ADDENDUM NO. 2 TO PROJECT NO. 42535

PROVIDE ELECTRIC UPGRADE FOR FEEDERS, TRANSFORMERS, AND SWITCHGEAR SITEWIDE

GREENHAVEN CORRECTIONAL FACILITY
ROUTE 216
STORMVILLE, N.Y. 12582

February 21, 2013

DRAWING NUMBER: EL1.11B

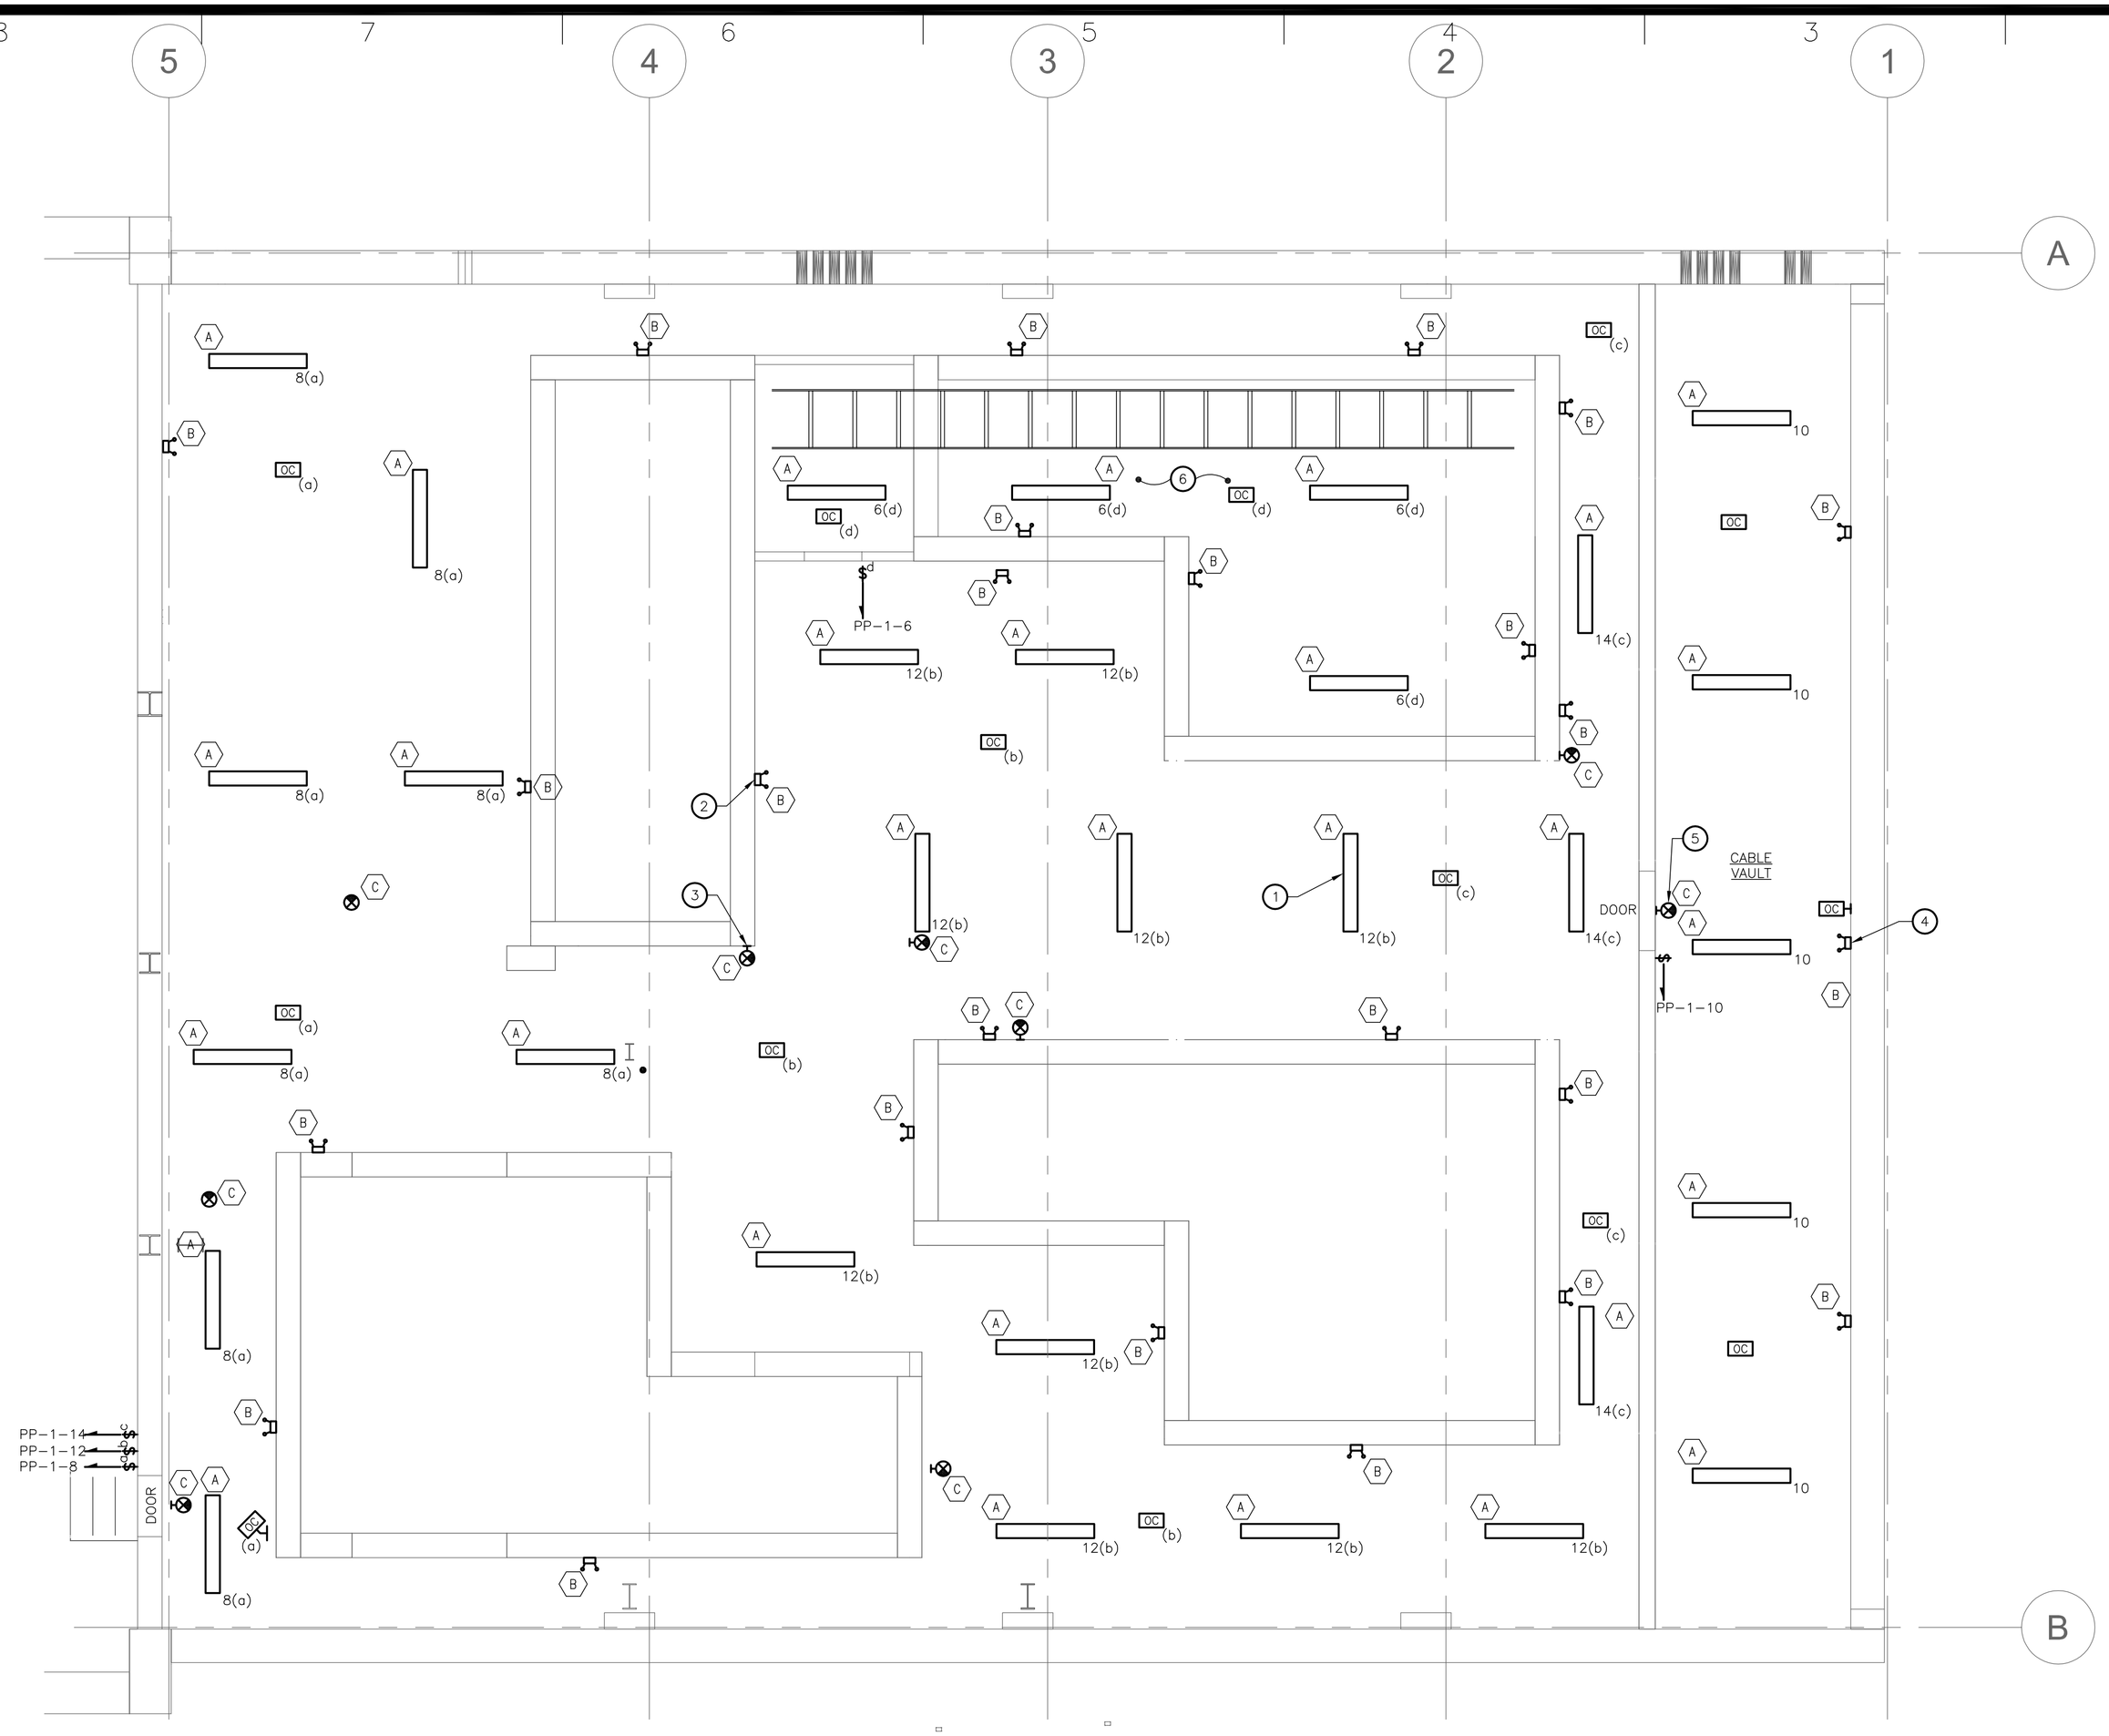
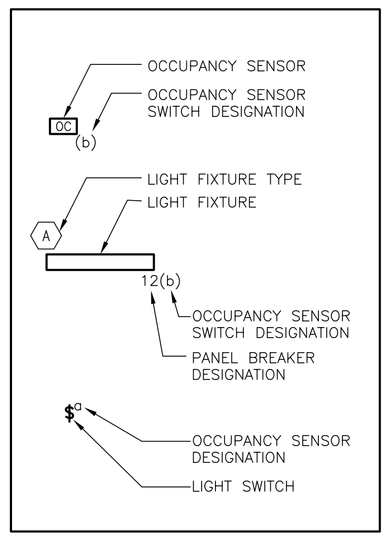
a. Revise "ENGINE ROOM – BASEMENT LIGHTING – ELEV. 411.5' – NEW WORK – PHASE 1". See accompanying drawing EL.1.11B.

DRAWING NUMBER: EL1.14B

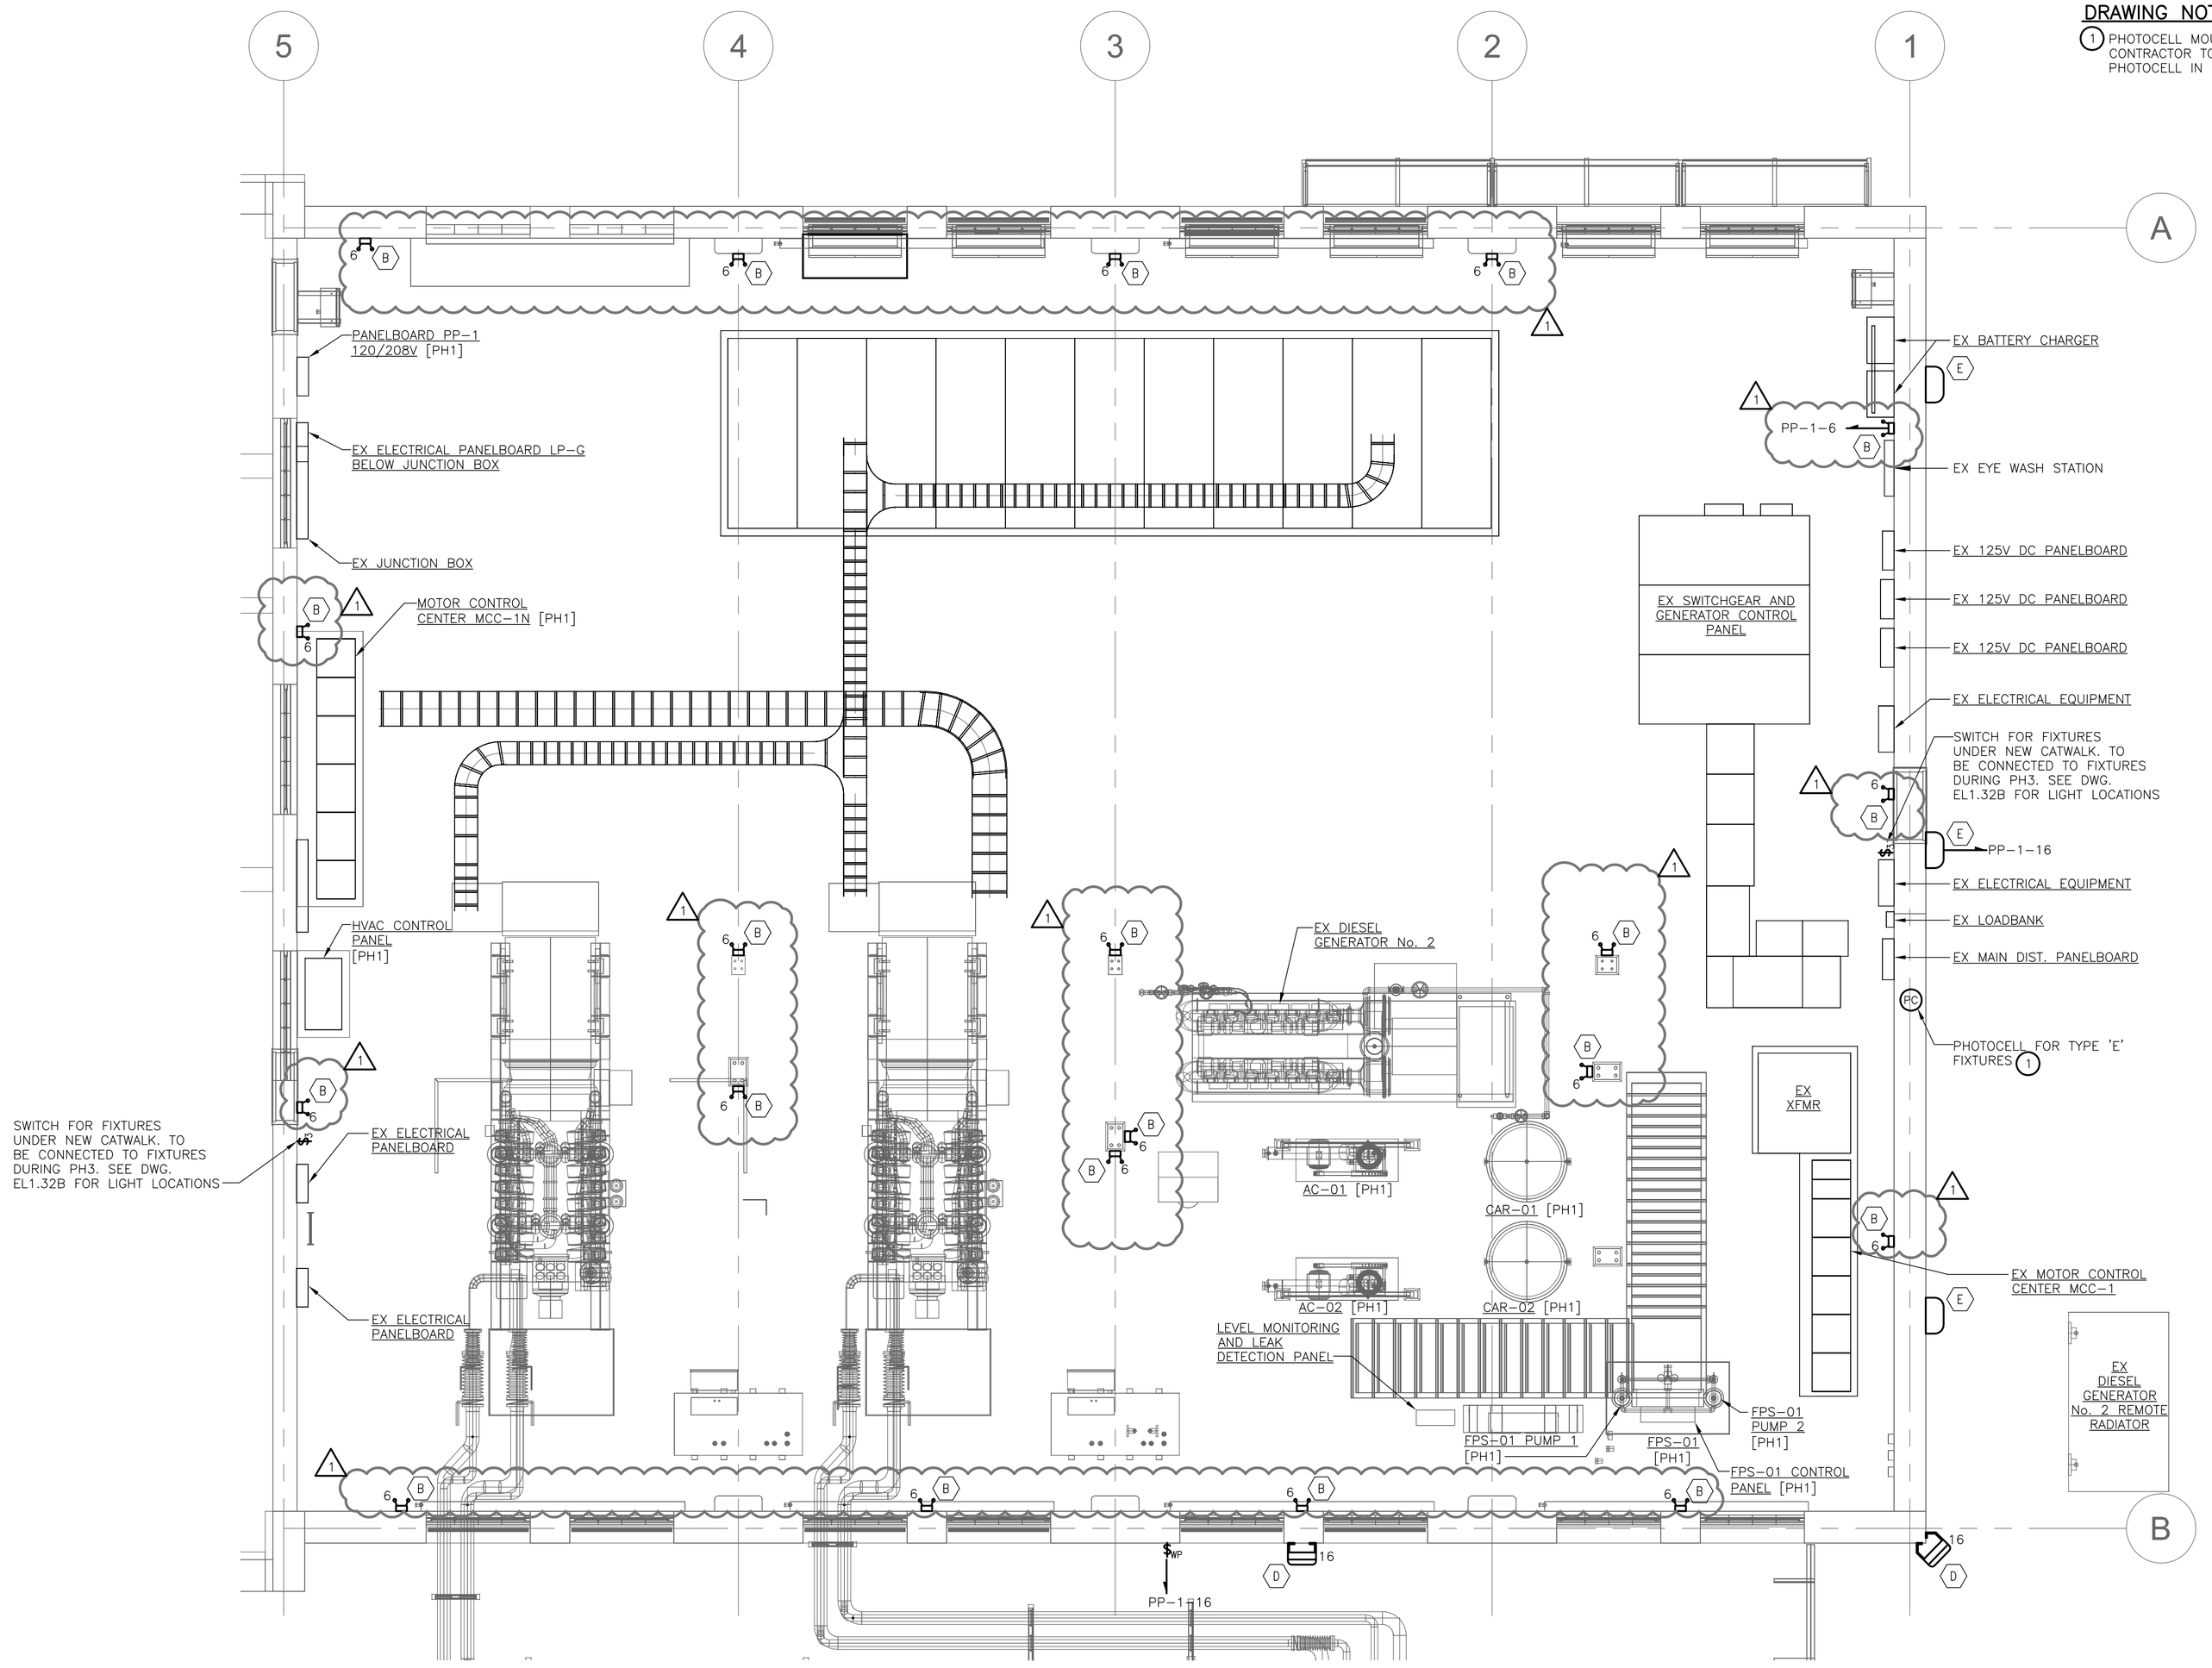
21. Drawing EL1.14B:
    a. Revise "ENGINE ROOM – LOWER LEVEL LIGHTING – ELEV. 422.5 – NEW WORK – PHASE 1". See accompanying drawing EL1.14B.
